ADDENDUM NO. :	Three (3)
BID DUE TIME AND DATE:	2:00 p.m., April 30, 2019 (No Change)
BIDDER QUESTIONS BY:	11:59 a.m., April 23, 2019
LAST ADDENDUM ISSUED:	11:59 p.m., April 25, 2019

BID NUMBER: BID-SJR-06-2018
RENOVATION WITH ADDITION TO BUILDING V ST. AUGUSTINE CAMPUS

ST. JOHNS RIVER STATE COLLEGE

04/17/19 ADDENDUM 3

A301

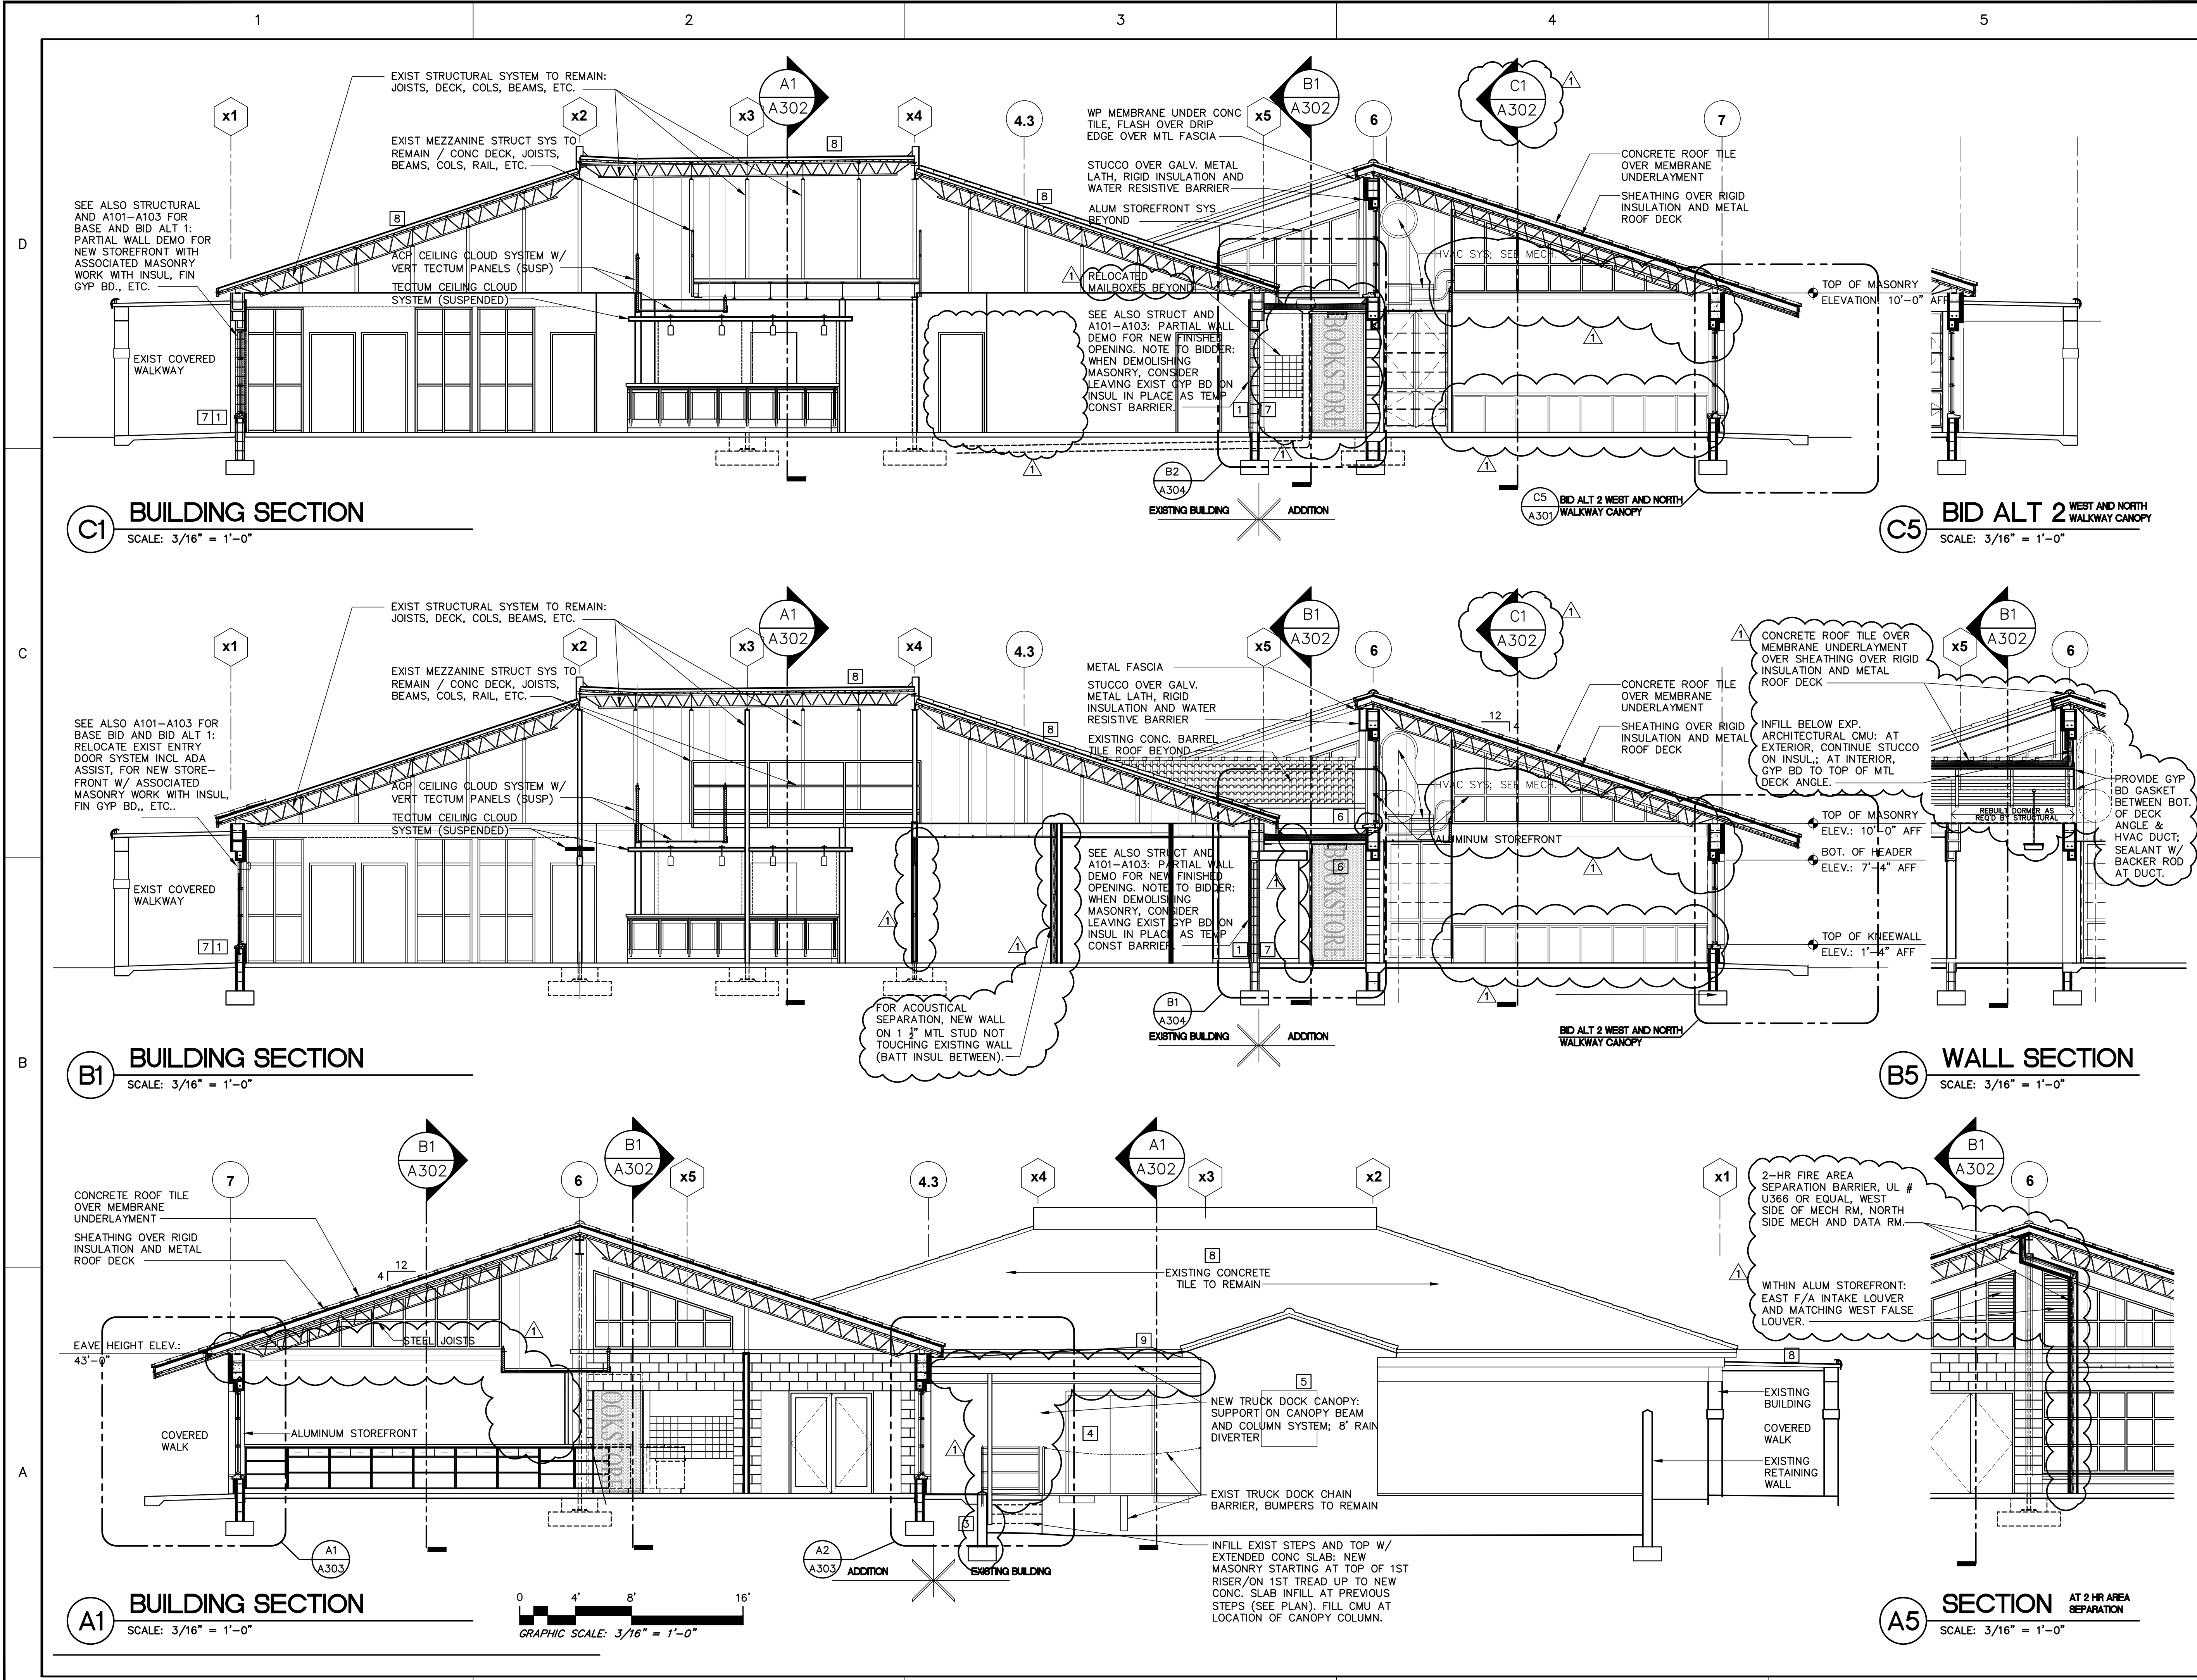
- F9 shows rectangular interior storefront, similar to F4 and F5 but with 6' width dimension. Visible in A1/A302 (left storefront in that Section incorrect/should match two to the right/north).
- F10 shows triangular interior storefront starting 10' AFF and visible on B1 and C1/A301.
- F11 shows rectangular interior storefront with perforated panel, similar to F4 but without internal mullions, and visible on A1/A301 with "BOOKSTORE" graphic.
- F3 adjusted to reflect Floor Plan with Doors off-center.
- F8 corrected to 6' wide panel (located at 10' AFF, south end of col line 6.)
- F7 (located 10' AFF) shifted above its lower window counterpart, and horizontal intermediate mullion corrected.

- Sections C1/A301 doors corrected adjacent to Café, clarified to show relocated mailboxes
- Sections B1/A301 wall section at offices revised to show storefront as shown on plans & A302; wall section between offices and restrooms revised to show intent for acoustical separation.

- B1/A301 roof drain w/ leader deleted as section taken beyond roofdrain.
- C1/A301 roof leader revised to show outfall direction/to truck dock.
- Sections modified to show HVAC ducts/equip to clarify overall intent regarding ceiling clouds serving as utility chase.

A302

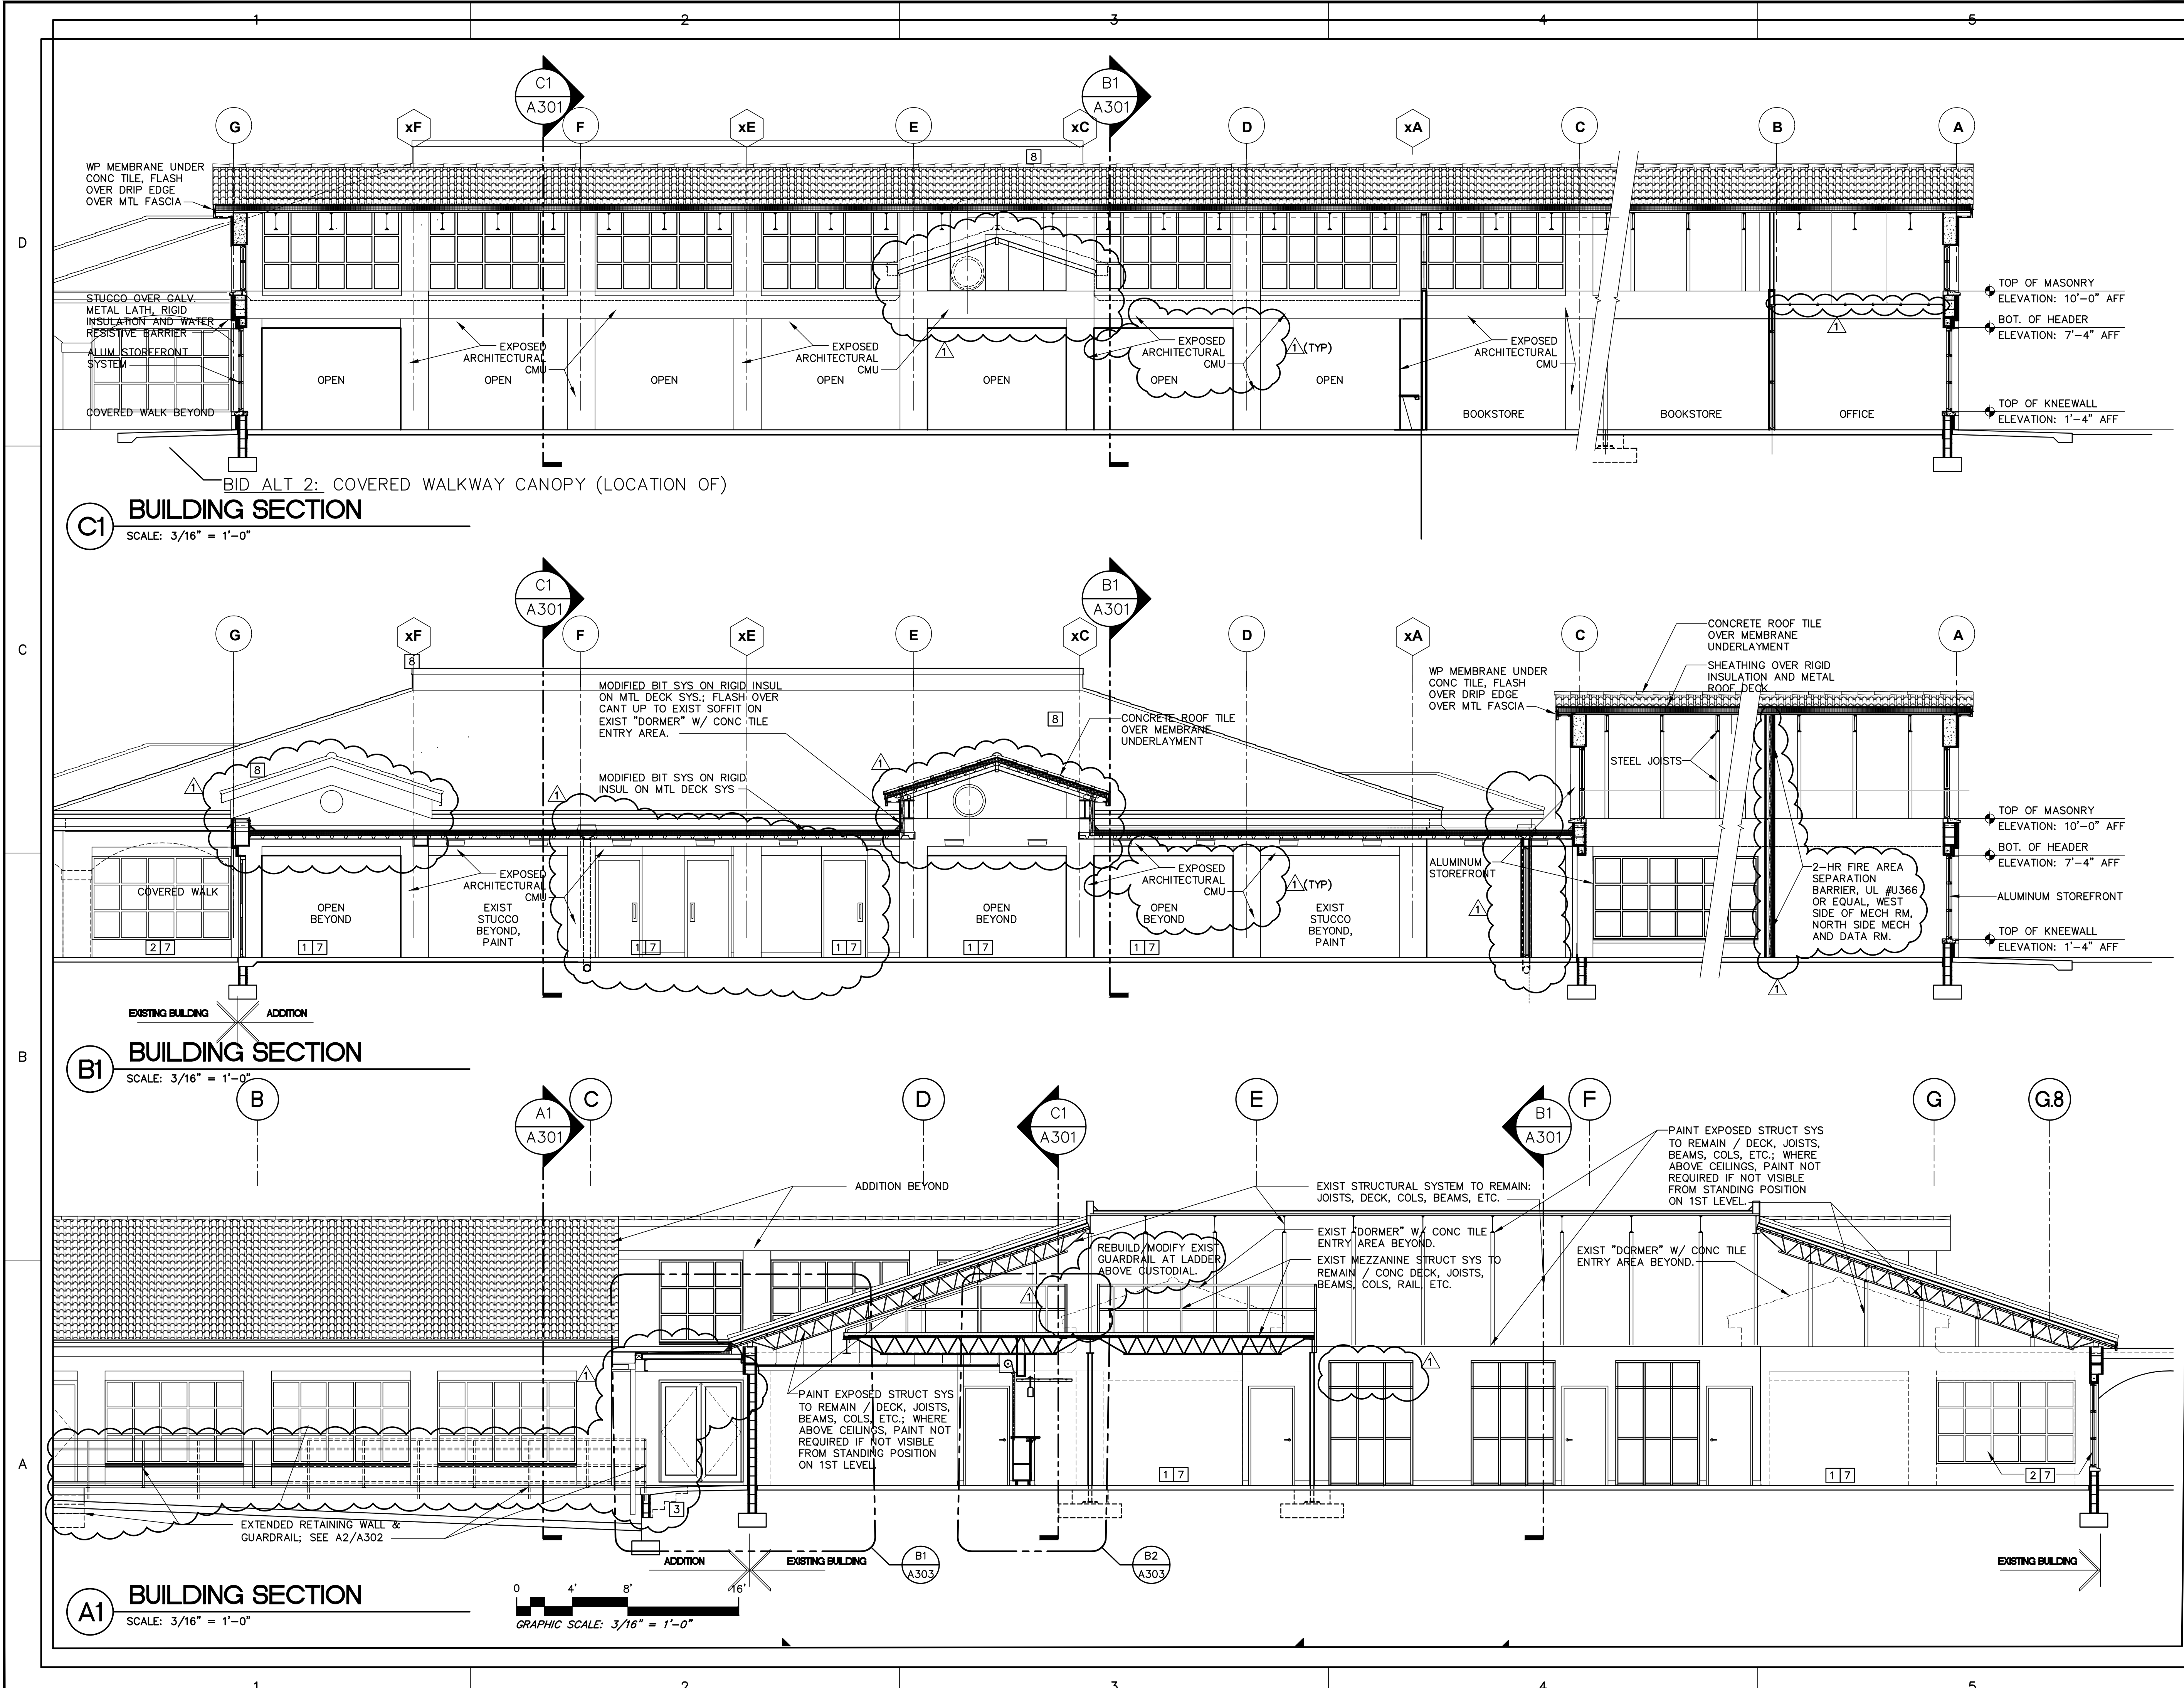
- Height of storefront for Room V0102
- Height of storefront with perforated panel,

B3 SECTION
SCALE: 1 1/2" = 1'-0"

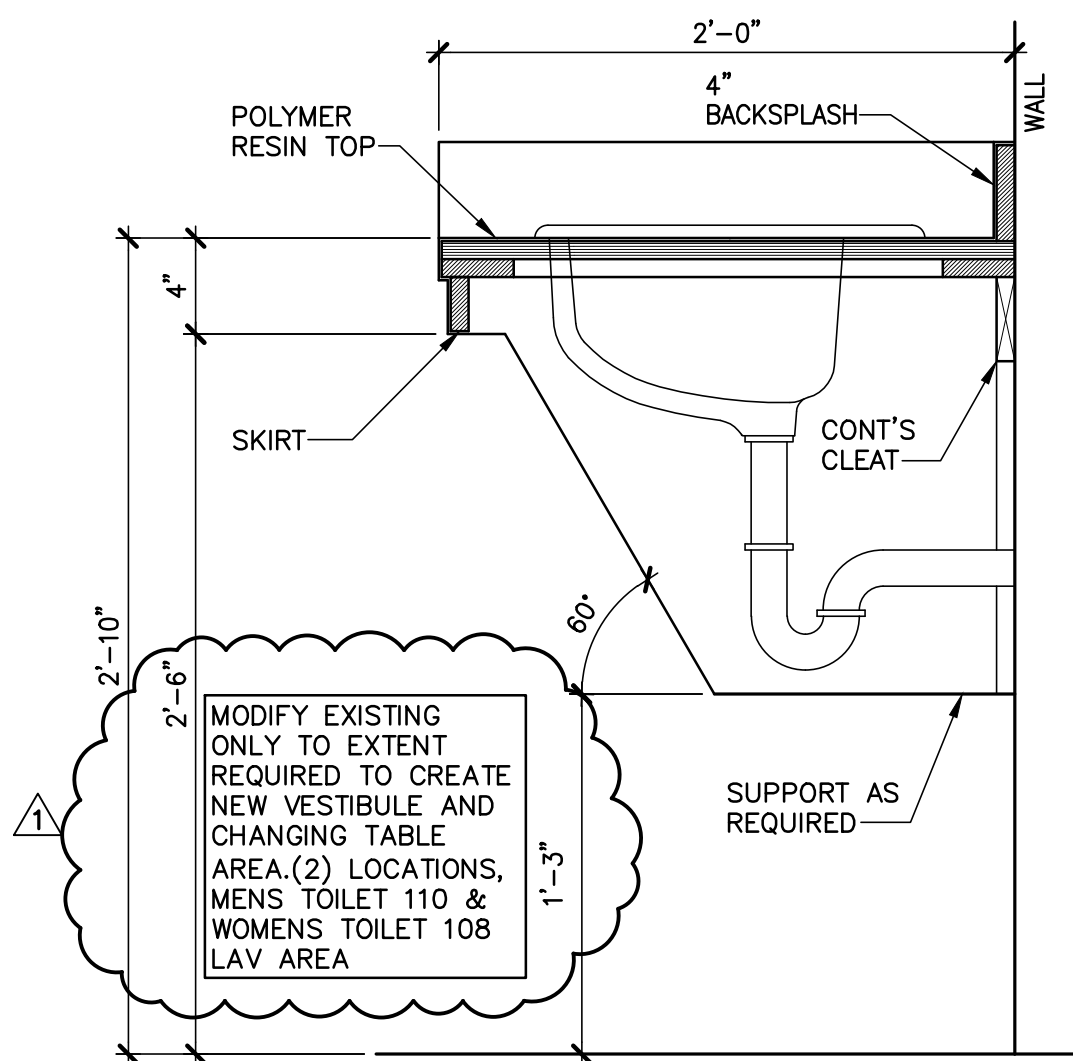
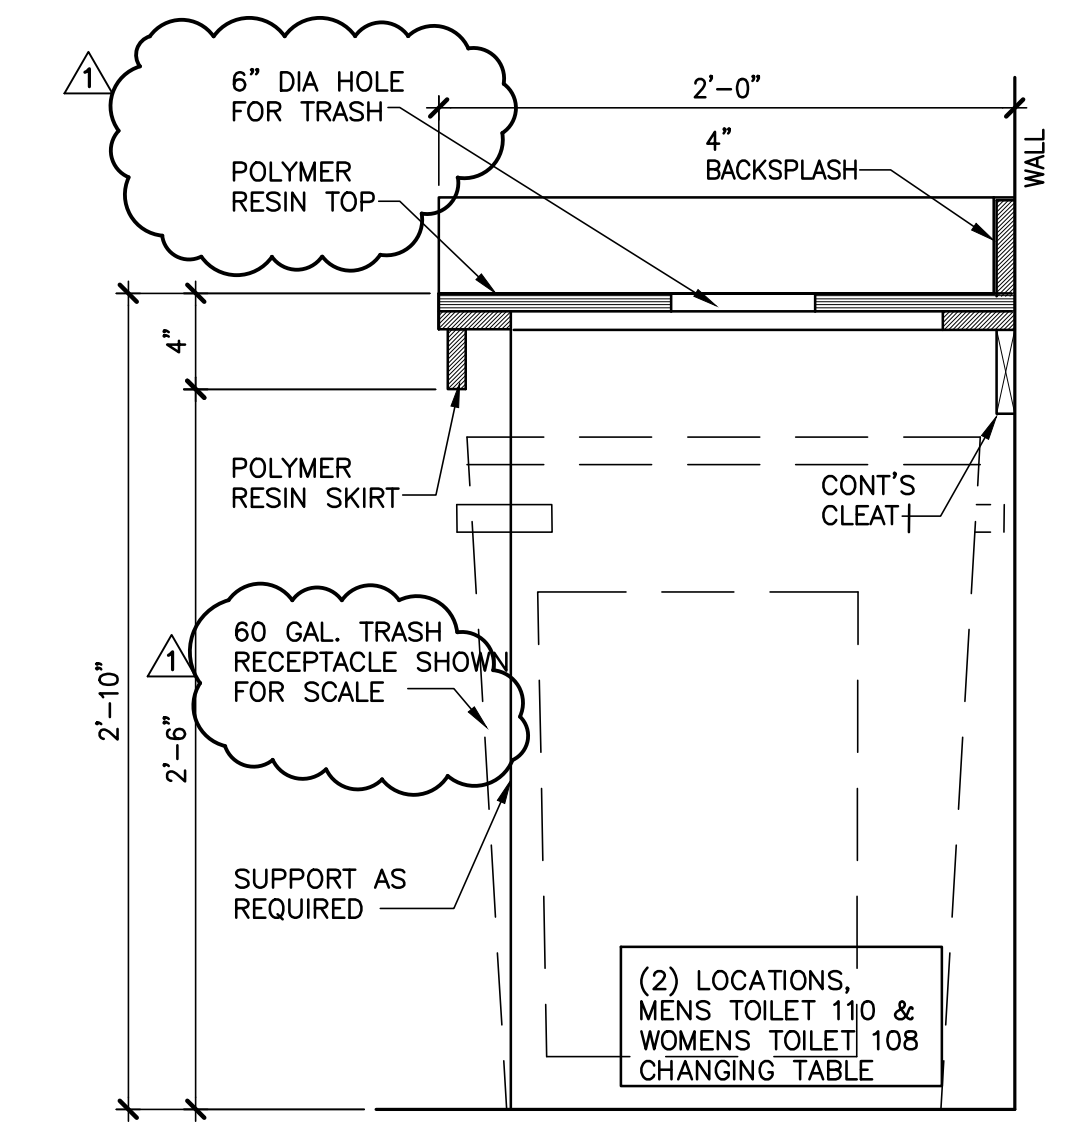
A1a: Section B3/A501 (Notation corrected from B4 to B3): Upper Section: Hole for discarding trash identified. Lower Section clarifies that it is not the intent to replace the counter, however Contractor Option to replace if it simplifies for creation of Changing counter.
